Point Beach Nuclear Plant, Units 1 and 2
Dockets 50-266 and 50-301
Renewed License Nos. DPR-24 and DPR-27

Supplement to License Amendment Request 252
Technical Specification 5.6.5, Reactor Coolant System (RCS)
Pressure and Temperature Limits Report (PTLR)

MARK-UP OF TRM 2.2
PRESSURE TEMPERATURE LIMITS REPORT

Figure 1
RCS PRESSURE-TEMPERATURE LIMITS FOR HEATUP

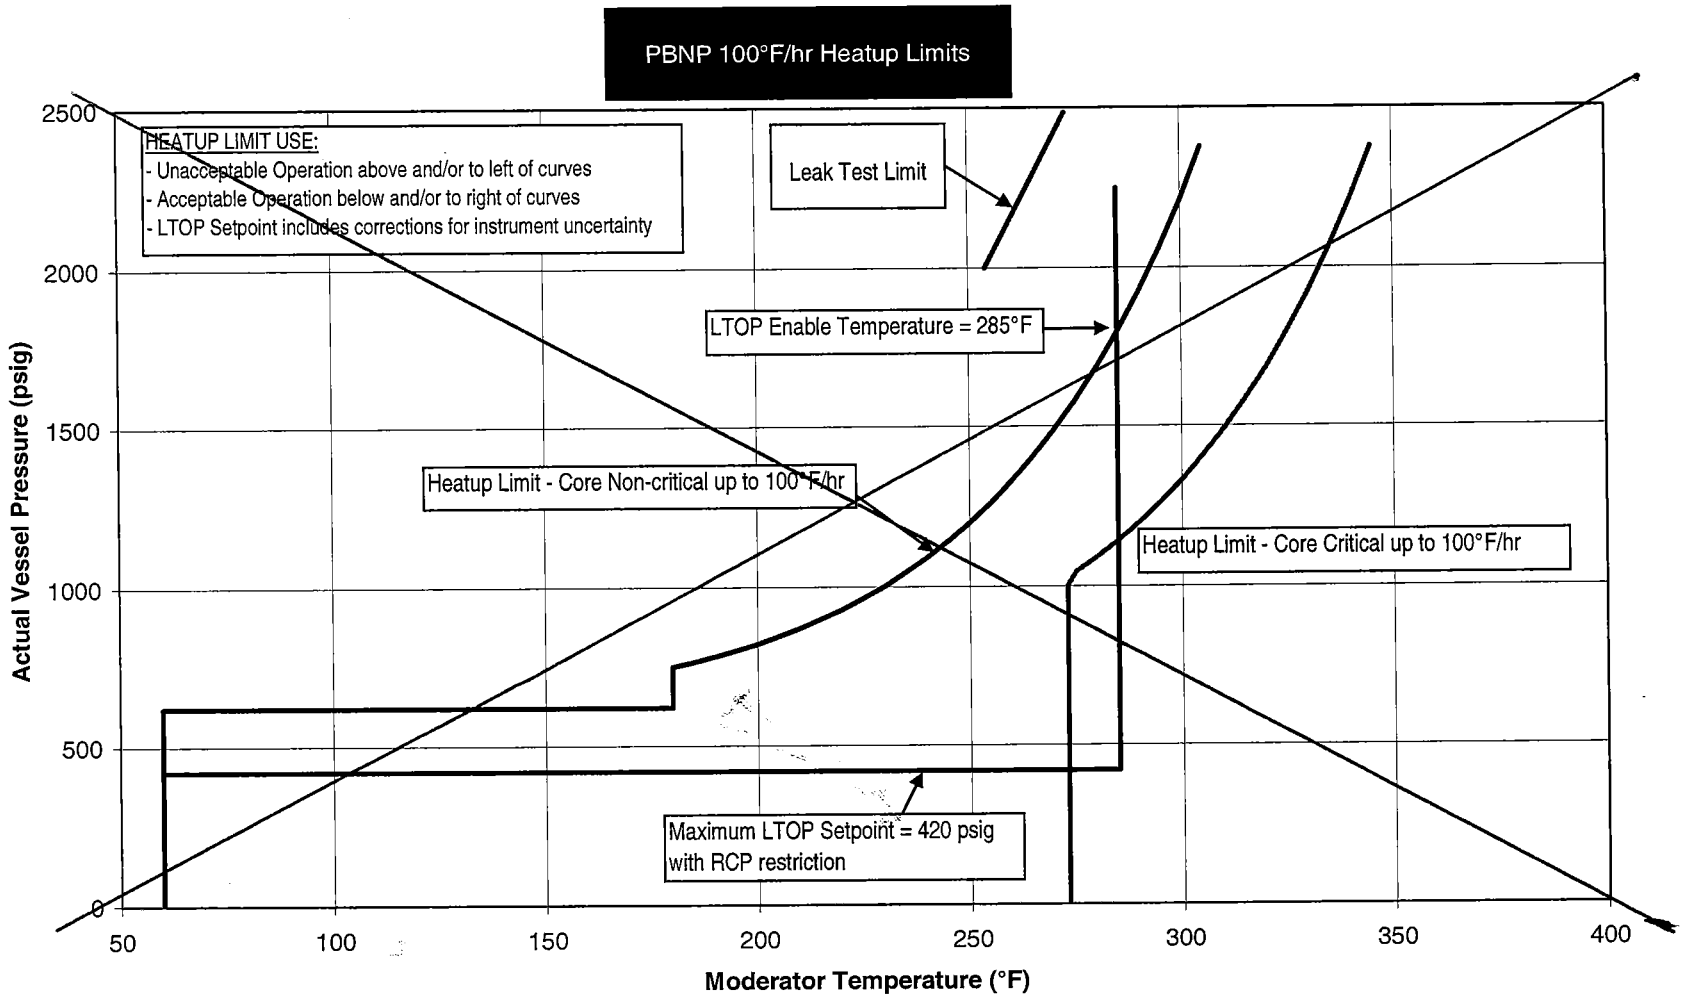
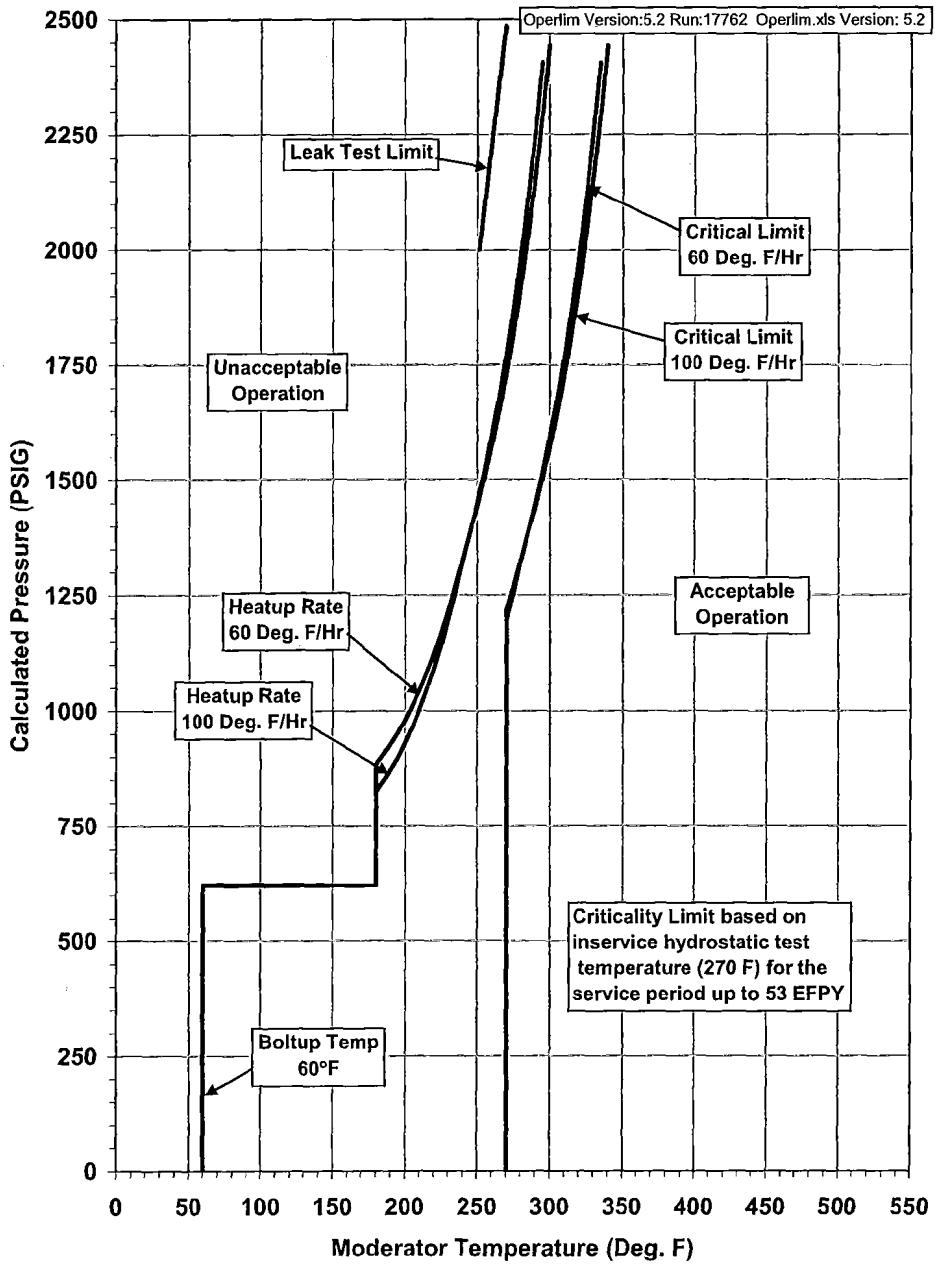
REPLACE FIGURE WITH FIGURE 5-7 OF WCAP-16669-NP

Figure 2
RCS PRESSURE-TEMPERATURE LIMITS FOR COOLDOWN

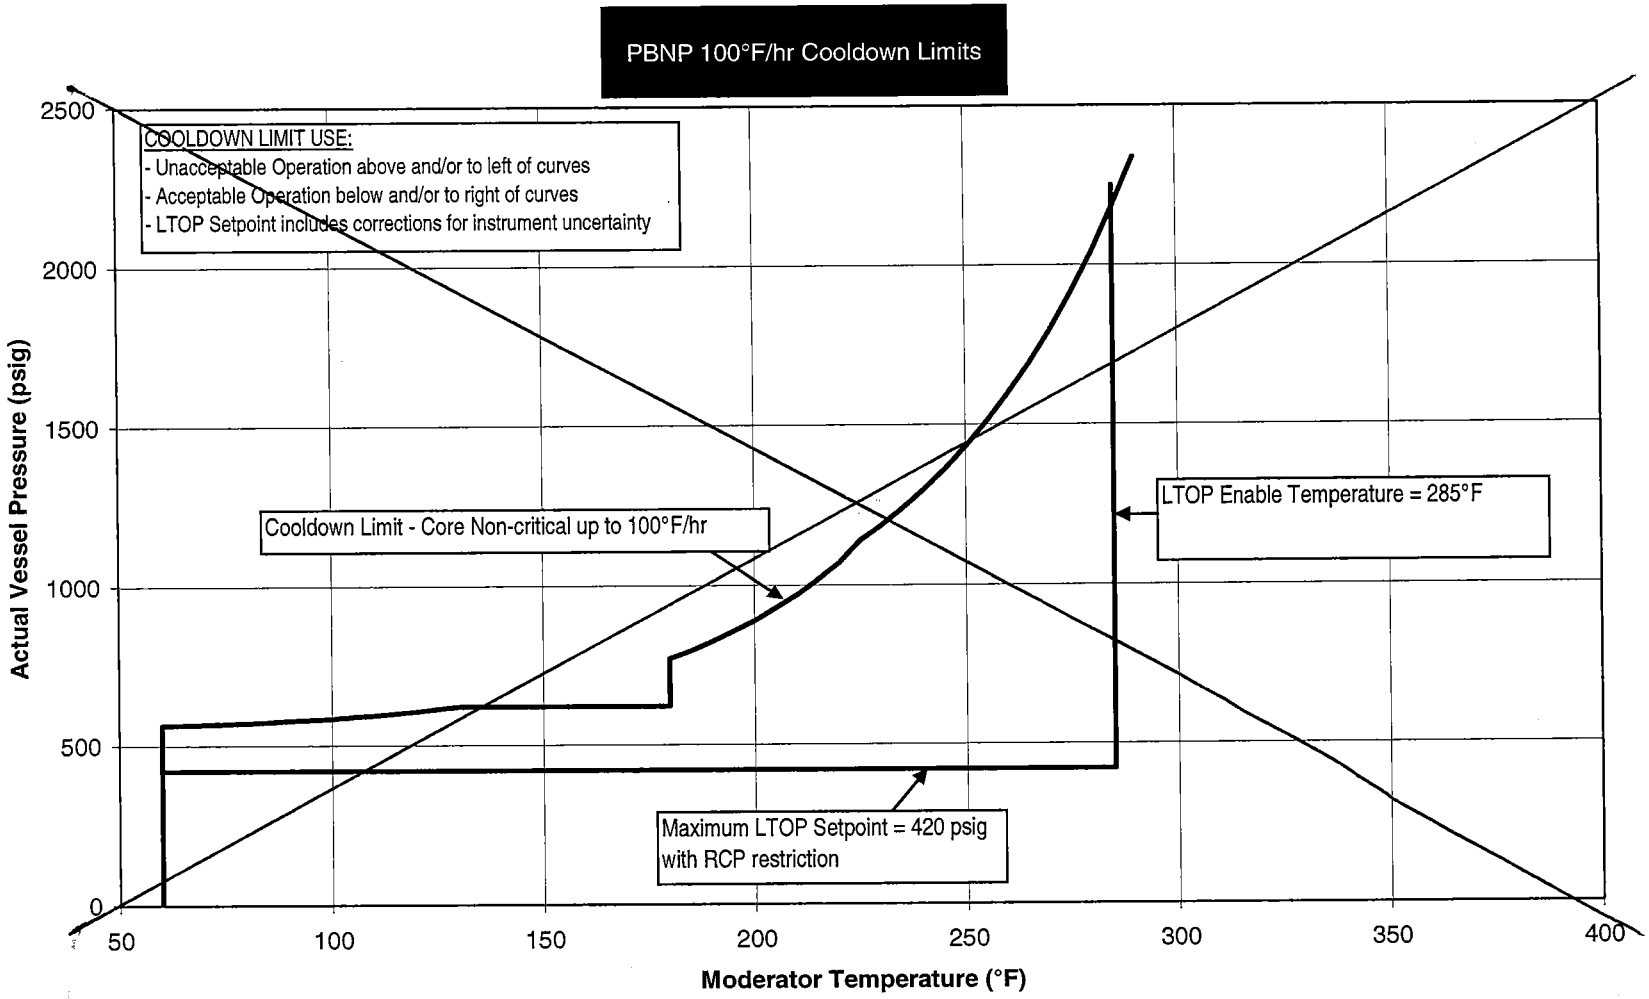
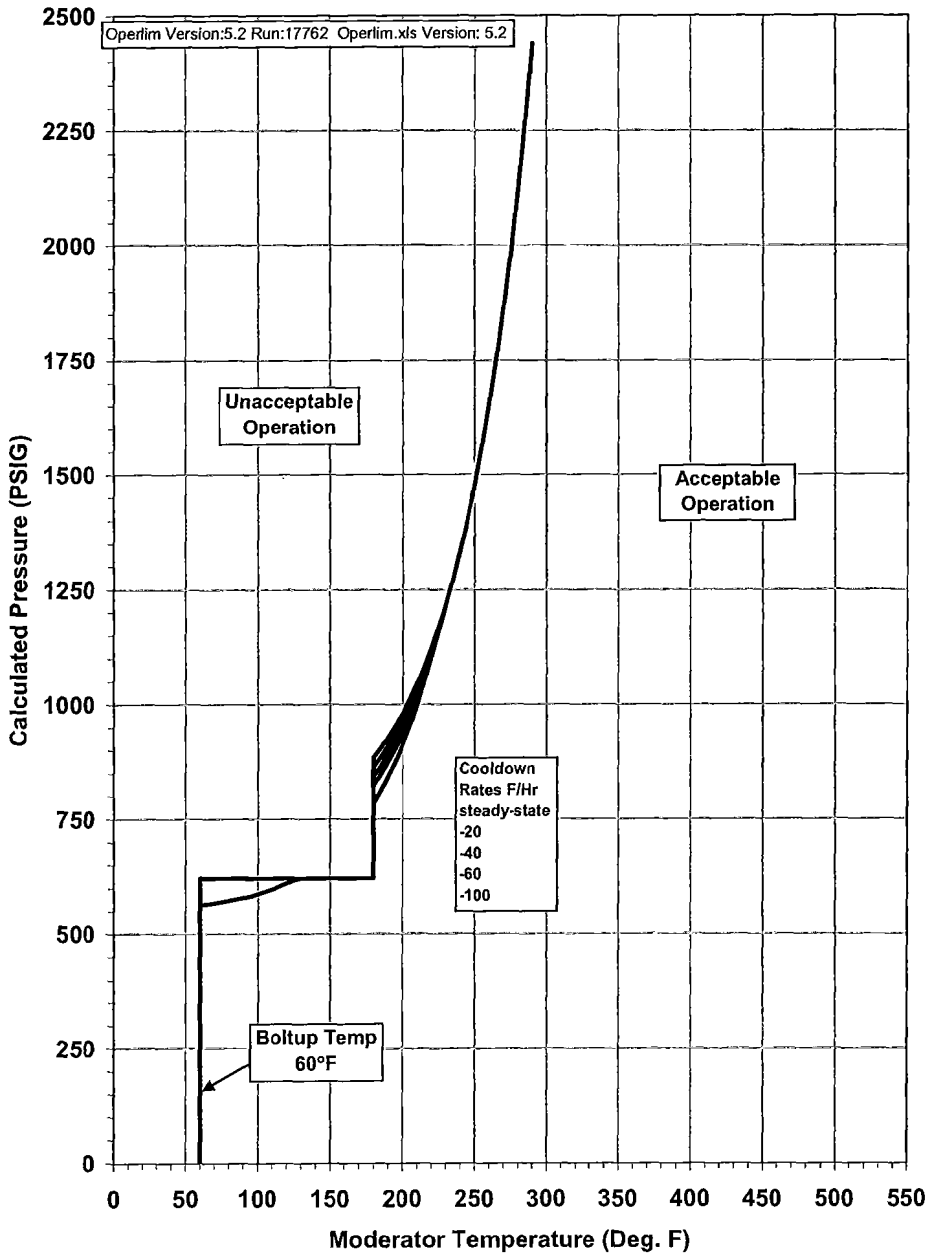
REPLACE FIGURE WITH FIGURE 5-8 OF WCAP-16669-NP
